## **Appendix A**

### **Review of Public Comments Received by the TWDB**

The United States Geological Survey, in cooperation with the Texas Water Development Board, has completed a groundwater availability model for the northern portion of the Gulf Coast Aquifer System (Ellis and others, 2023). This model meets TWDB modeling, public comment, and stakeholder involvement standards. Therefore, this model is now the current groundwater availability model for the northern portion of the Gulf Coast Aquifer System. This appendix is ancillary to the model report, and contains the public comments received and responses to those comments. The model report can be found at <https://pubs.usgs.gov/publication/pp1877> or [https://www.twdb.texas.gov/groundwater/models/gam/glfc\\_n/glfc\\_n.asp](https://www.twdb.texas.gov/groundwater/models/gam/glfc_n/glfc_n.asp).

### Lone Star Groundwater Conservation District (LSGCD)

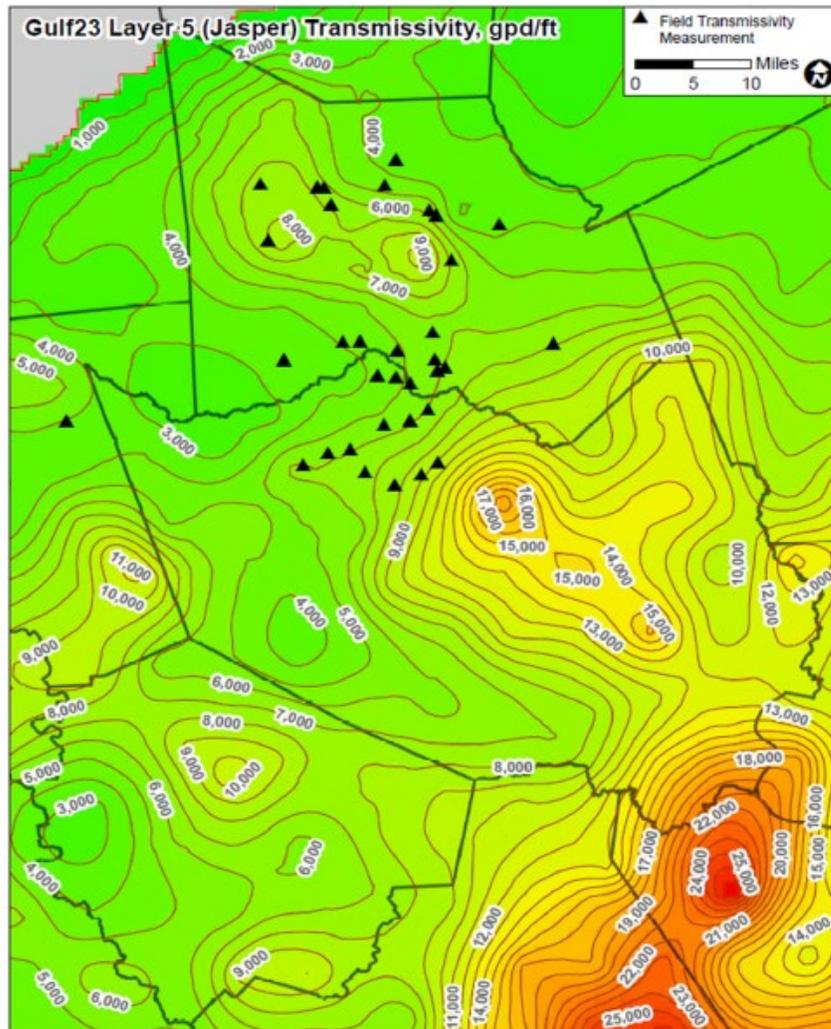
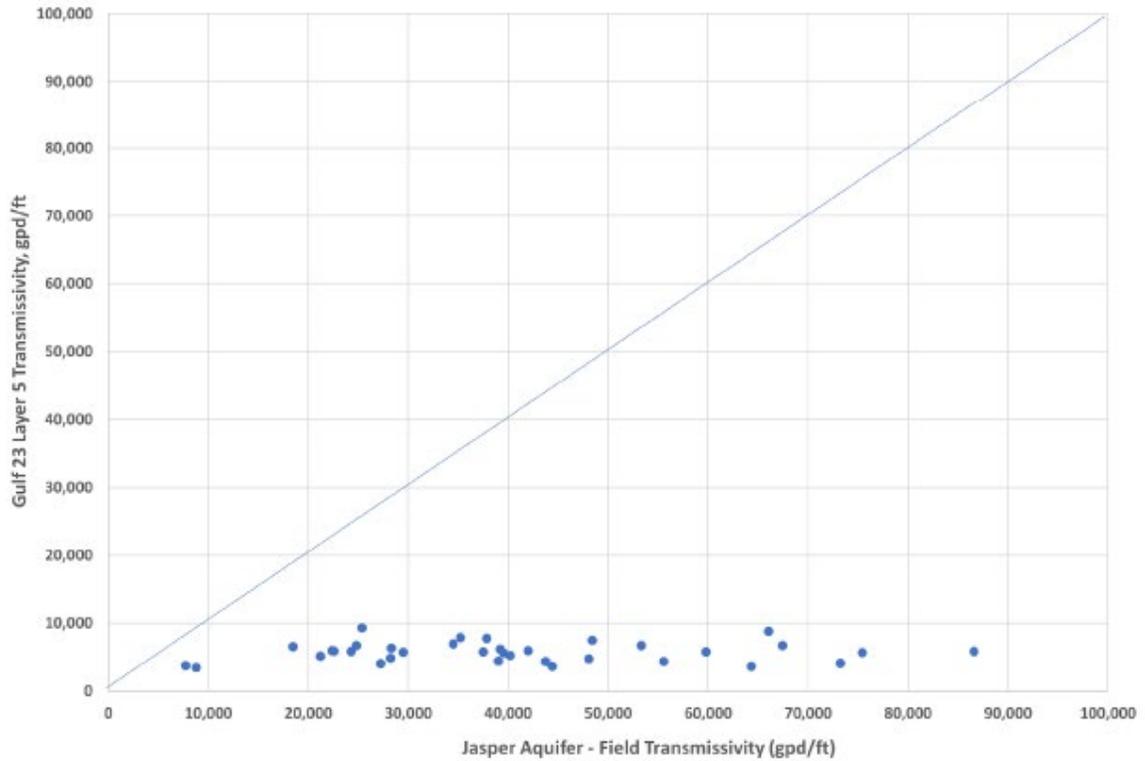
The Gulf23 Layer 5 (Jasper) transmissivity values appear to be substantially lower than transmissivity estimates derived from large capacity water well pumping tests. This observation can be noted regionally in Montgomery County, north Harris County and Waller County. What aquifer parameters are contributing to the overall lower Jasper Aquifer transmissivity values that have been developed for Layer 5 of the Gulf23 model?

Montgomery County and north Harris County are key areas of groundwater production from the upper Jasper Aquifer and lower model transmissivity values could result in higher water level drawdown estimates compared to higher model transmissivity values.

What is the basis for the relatively high Jasper Aquifer transmissivity values of +/- 17,000 gpd/ft in central Harris County?

What is the basis for the higher +/- 25,000 gpd/ft Jasper Aquifer transmissivity estimates in areas of north Brazoria and north Galveston County?

The Jasper Aquifer one-to-one plot above compares estimated transmissivity values in the Gulf23 model (Layer 5) to estimated transmissivity values derived from field testing of large capacity water wells completed in the Jasper Aquifer at common locations in Montgomery, Harris (north) and Waller counties. The plot shows that the estimated Gulf23 Layer 5 transmissivity values appear to be substantially lower than the field transmissivity estimates based on large capacity well pumping test data. What is the justification for the consistently low modeled Jasper transmissivity values which are contradicted by pumping test results?

*Response: This is a combined response for the transmissivity questions. When evaluating a model, examining the horizontal hydraulic conductivity as opposed to the transmissivity removes the complication of evaluating the unit layer thickness simultaneously. The layers are substantially thick and include many clay lenses that would not be screened by production wells where transmissivity has been determined. The calibrated horizontal hydraulic conductivity values used in the model are reasonable and align with published horizontal hydraulic conductivity values used in groundwater models across the Gulf Coast Aquifer System.*

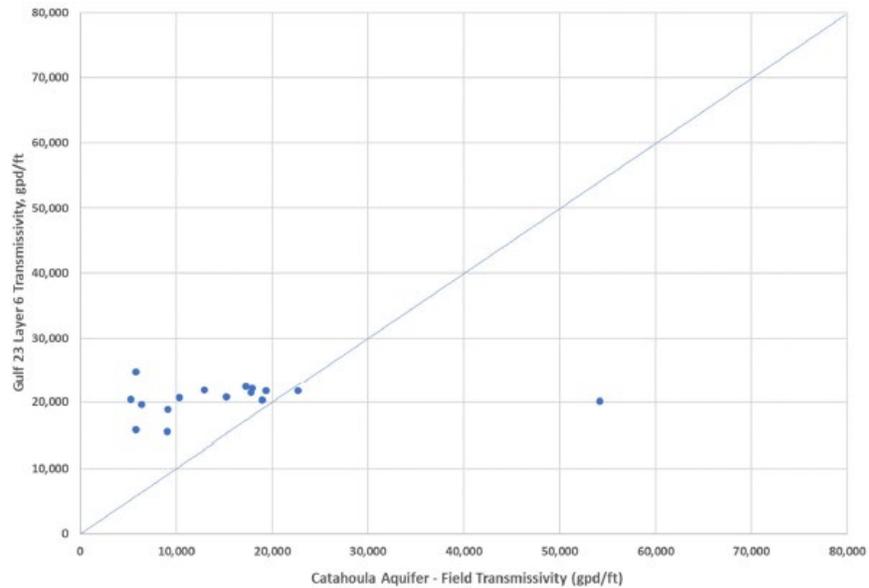
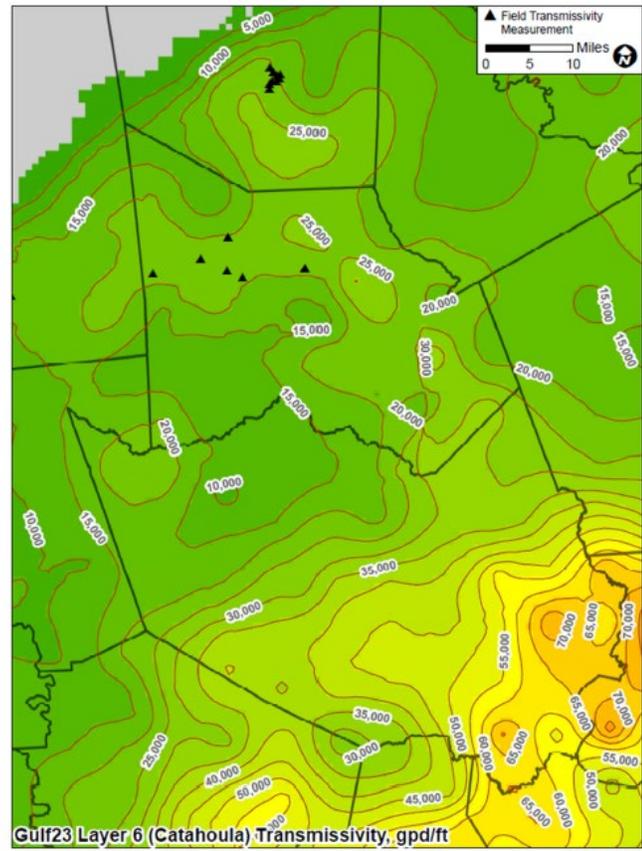
The Catahoula Formation one-to-one plot above compares estimated transmissivity values in the Gulf23 model (Layer 6) to estimated transmissivity values derived from field testing of large capacity water wells completed in the Catahoula Formation. The field data are from large capacity water wells located in Montgomery and Walker counties. The plot shows that the estimated Gulf23 Layer 6 transmissivity values appear to be generally higher than the field transmissivity estimates based on large capacity well pumping test data.”

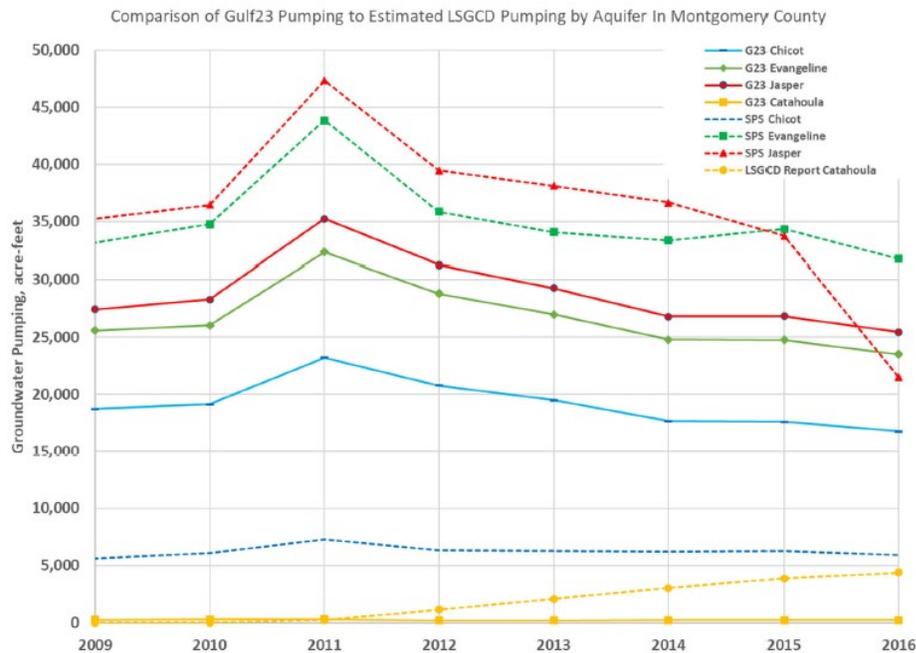
The graph below compares the total Gulf23 pumping to reported LSGCD and TWDB Water Use values in Montgomery County.

On a County wide basis, the total Montgomery County pumping generally appears to be reasonable and all datasets reviewed follow the same general trend with time.

The TWDB Water Use data available for Montgomery County generally follows the same pumping trend shown in the LSGCD reported data with time. The TWDB water use data may overestimate groundwater pumping because it includes non-surveyed estimates related to irrigation, mining, municipal and livestock pumping.

The total Gulf23 pumping in Montgomery County does not recognize the County wide reduction in groundwater pumping that began in 2015 and the Gulf23 pumping overestimates the County wide pumping from 2016 through 2019. Why was the reduction

in pumping in 2015 not reflected in the Gulf23 pumping dataset despite being shown in the referenced TWDB Water Use dataset?"

*Response: INTERA used groundwater data from the TWDB Water Use Survey (historical water use estimates) for 1974, 1980, and 1984–2018 (or an interpolation during the intervening years) to construct the pumping dataset for the GULF model. For Montgomery County, the LSGCD groundwater use for 2016–2018 was about 80 percent of the groundwater use in the TWDB Water Use Survey (historical water use estimates). The “TWDB Water Use dataset” described in the comment above is the TWDB historical groundwater pumpage dataset, which was not used to construct the WEL file.*

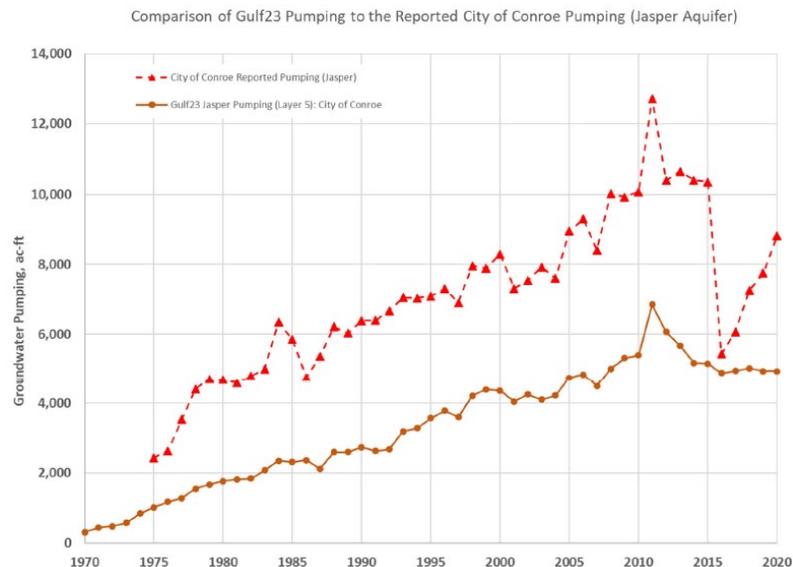
14. [comments 15 and 16] “The graph below compares Gulf23 pumping by layer (solid lines) to LSGCD reported groundwater pumping by aquifer estimates that were developed for Task 3 of the LSGCD Strategic Planning Study by LBG-Guyton Associates (dashed lines). Pumping has historically been reported to LSGCD based on total annual pumping and is not typically available on a per well basis. LBG-Guyton worked with LSGCD staff to develop pumping estimates by well for the 2010 through 2016 period as part of the Strategic Planning Study. LSGCD has tracked the development of groundwater production from the Catahoula Formation on an annual pumping per well basis.

Gulf23 groundwater pumping appears to be overestimated in the Chicot Aquifer in Montgomery County.

Gulf23 groundwater pumping appears to be underestimated in the Evangeline Aquifer, Jasper Aquifer and Catahoula Formation in Montgomery County.

Much of the Montgomery County pumping is from the Evangeline and Jasper Aquifers. There are concerns that use of underestimated groundwater pumping values in the Gulf23 model calibration could result in development of parameters that could result in overpredictions of drawdown and subsidence in future / predictive pumping simulations.

*Response: The base of the hydrogeologic units used in the GULF model were updated as described in Young and Draper (2020). As a result of intersecting the production well screens to the updated hydrogeologic unit thicknesses, a number of wells and corresponding groundwater use previously assigned to the Evangeline aquifer were reclassified to the Chicot aquifer.*

*The final pumping dataset, the methods, and the assumptions and limitations are described in Oliver and Harmon (2022). Regional scale groundwater availability models are not to be used for comparison at individual wells. However, the overall volume of pumping applied in each county is representative of the total county water use.*

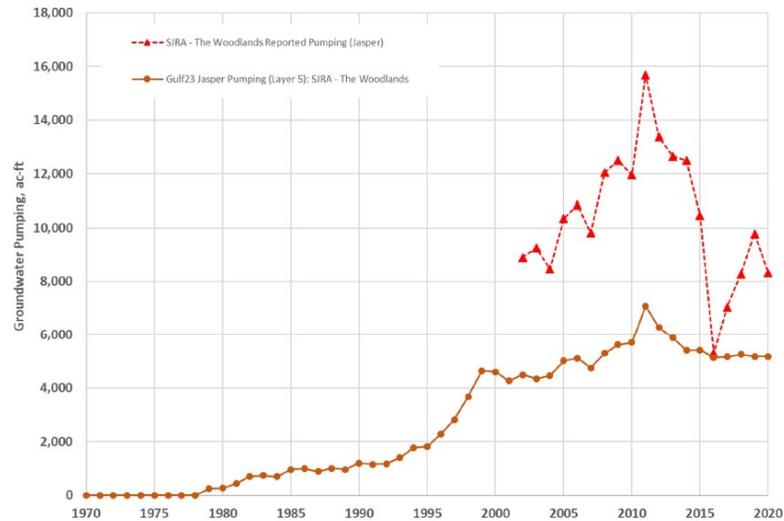
The graph below shows a comparison of actual reported SJRA-The Woodlands pumping from the Jasper Aquifer to the Gulf23 Layer 5 pumping representing SJRA- The Woodlands Jasper wells. There is a significant difference in the reported and simulated Jasper Aquifer annual pumping total representing the SJRA – The Woodlands wells that screen the Jasper Aquifer. The Gulf23 Jasper pumping for SJRA-The Woodlands is substantially less than its reported Jasper pumping and the Gulf23 Jasper pumping does not represent the pumping reduction that occurred in 2016 as more surface water became available in part of Montgomery County.

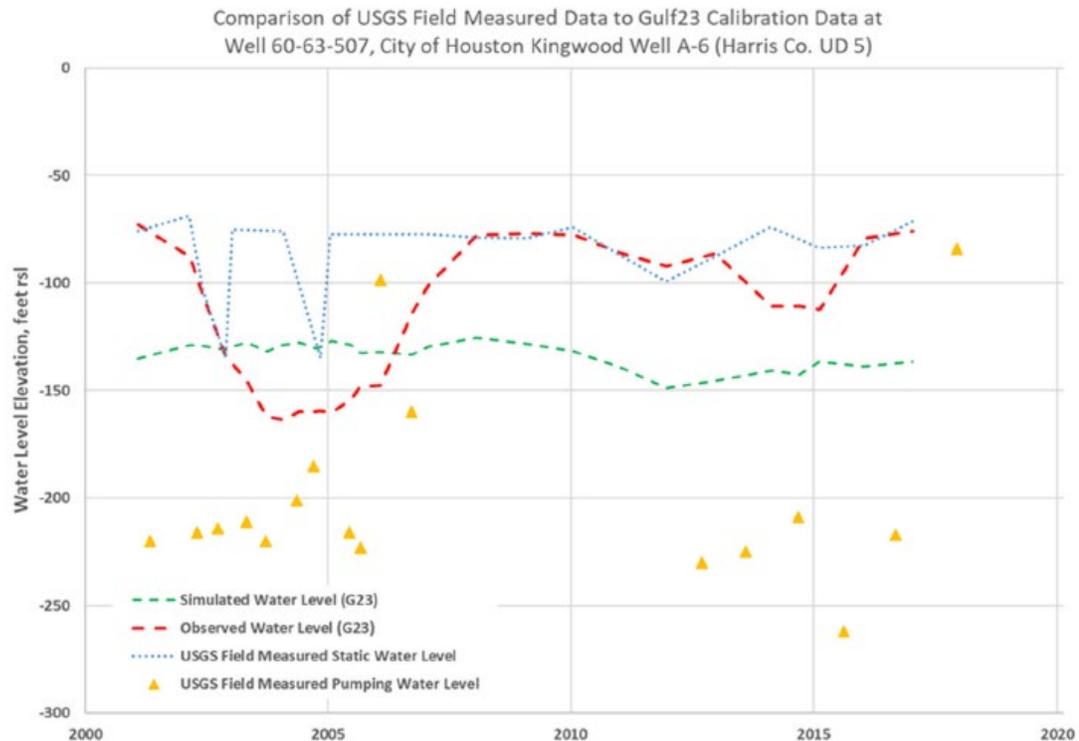
A majority of the water wells screening the Jasper Aquifer in Harris County are located in north Harris County in an area generally west of Interstate 45, north of Farm-to-Market Road 1960 and north of Highway 290. Multiple water providers began constructing wells screening the Jasper Aquifer beginning in the late 1990's and early 2000's. Prior to that time, there were only a limited number of wells that screened Jasper Aquifer sands in Harris County. AGS personnel are familiar with the development of pumping from the Jasper Aquifer in north Harris County and have reviewed pumping by well in the Jasper Aquifer several times in the past. The Gulf23 model appears to underestimate the Jasper Aquifer pumping in north Harris County when compared to reported Jasper Aquifer pumping. Additional review of recent north Harris County Jasper Aquifer pumping has not been performed since about 2016.

There are concerns about underestimated pumping amounts being used in the calibration of the Jasper Aquifer in the Gulf23 model. Groundwater pumping is an important input for model calibration. If Gulf23 Jasper Aquifer pumping estimates are less than what has been reported and then are used and compared to measured aquifer water level and subsidence data to develop model parameters, what is the likelihood of those model parameters providing reasonable predictions of future water level decline and subsidence estimates?"

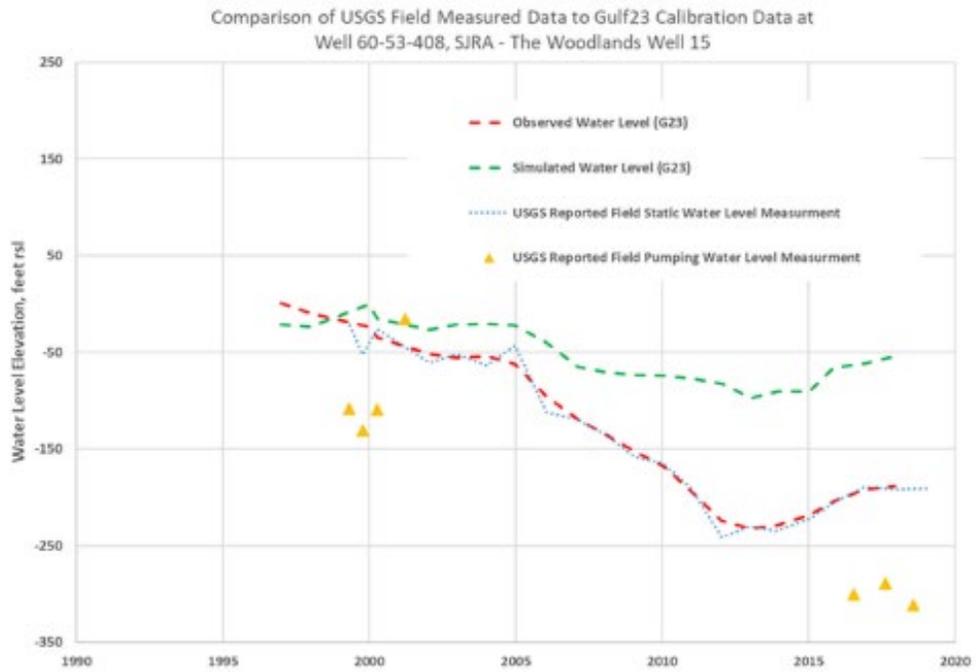
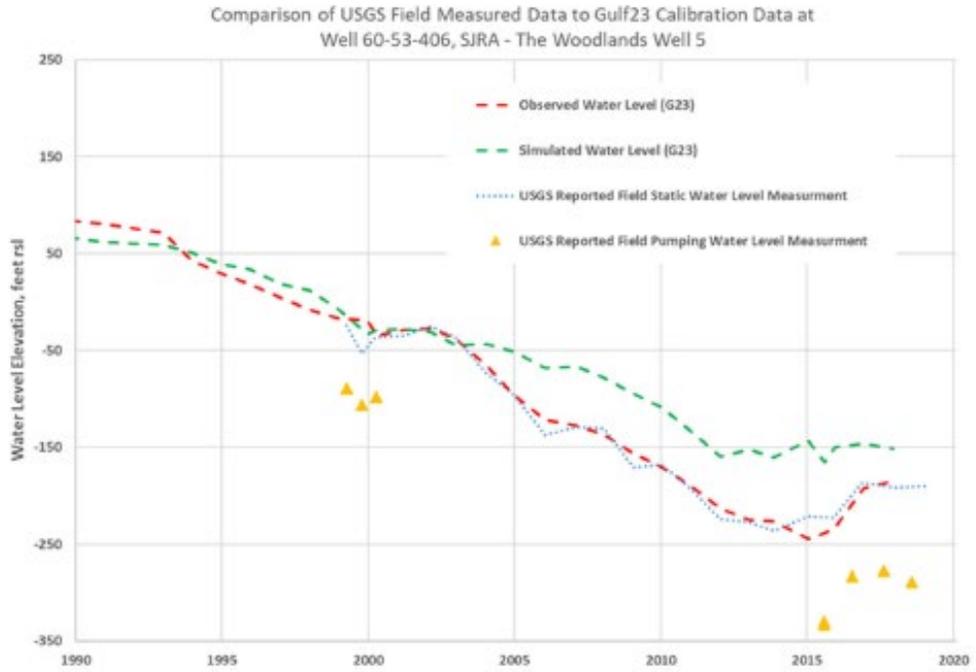
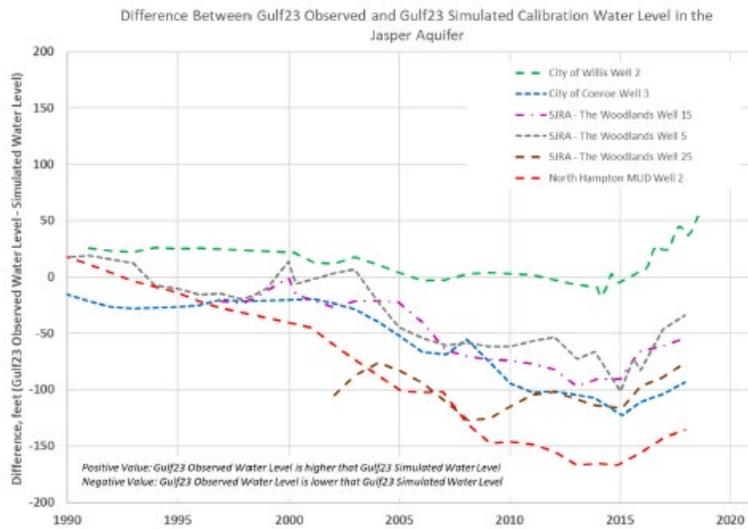
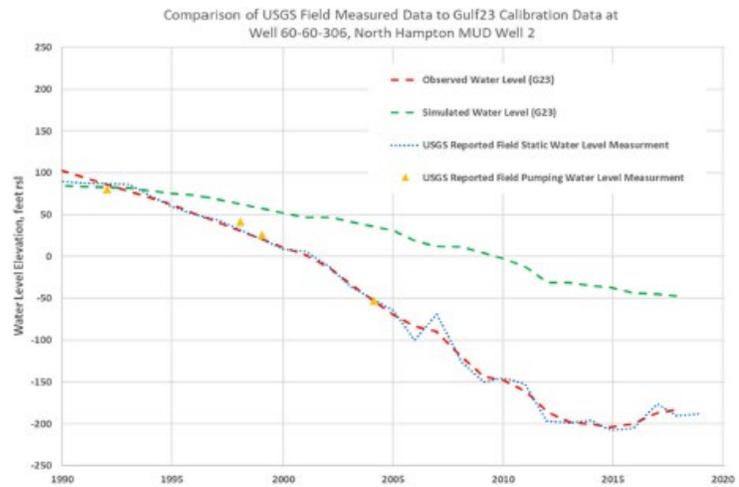
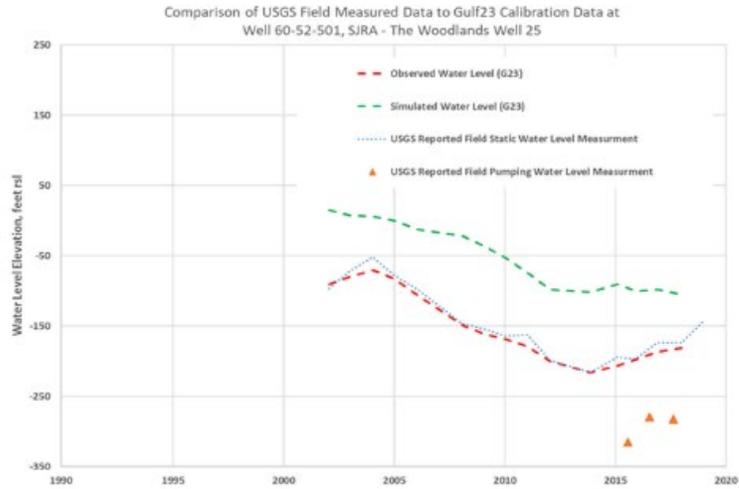
16. [comment 18] “Below is a series of charts comparing the Gulf23 calibration target data to USGS field measured static and pumping water level data for water wells completed in the Jasper Aquifer. Examples reviewed include the City of Willis Well 2, City of Conroe Well 3, SJRA – The Woodlands Wells 5, 15 and 25 and North Hampton MUD Well 2.

Generally, the two-year water level smooth applied to these wells appears to work well on the Jasper Aquifer wells reviewed. Limited pumping water level data is available for the wells reviewed. The classification as some of the USGS field measured pumping water levels as such is questionable as they can be generally similar to the reported static water level.

However, it appears that none of the simulated Gulf23 Jasper Aquifer water levels replicated the shallower static water levels that were noted in the observed data after 2015. What is the explanation for this inaccuracy of the simulated water levels after 2015?

In addition, there can be a minimum of 50 feet (5 of 6 wells), a minimum of about 100 feet (3 of 6 wells) and up to approximately 165 feet of difference (1 of 6 wells) between the Gulf23 simulated and observed Jasper Aquifer water levels in the datasets reviewed for the 6 wells identified in the previous charts. Could the authors please comment on how differences mentioned above affect water level calibration and the ability of the model to predict subsidence.”

*Response: The full extent of the Jasper aquifer water level recovery could not be fully matched without using unreasonable hydraulic conductivity parameter values. However, the overall pattern of groundwater level declines through about 2015, and the subsequent recovery is reproduced by the GULF model and the ensemble.*

*The modeled subsidence in Montgomery County is reasonably close, as shown in report figures 140–141. Vertical displacement at the GPS stations in Montgomery County is also reasonably close, as shown in report figures 157–158.*
